## Product Change Notification - SYST-01DHOH680

ERRATA - SAM D21 Family Silicon Errata and Data Sheet Clarification

## SAM D21 Family Silicon Errata and Data Sheet Clarification

**Table 2-1. Crystal Oscillator Checklist**

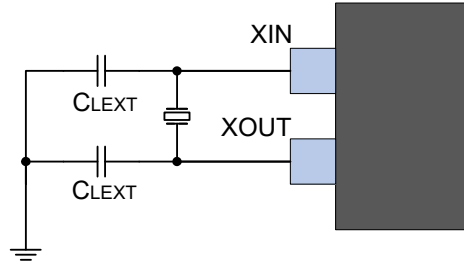
The load capacitor values shown in figure 42-6 and table 42-5 should not be used.  $C_{LEXT}$  should be calculated from the Load Capacitance Equation listed below. The corrected information is shown in **BOLD** type.
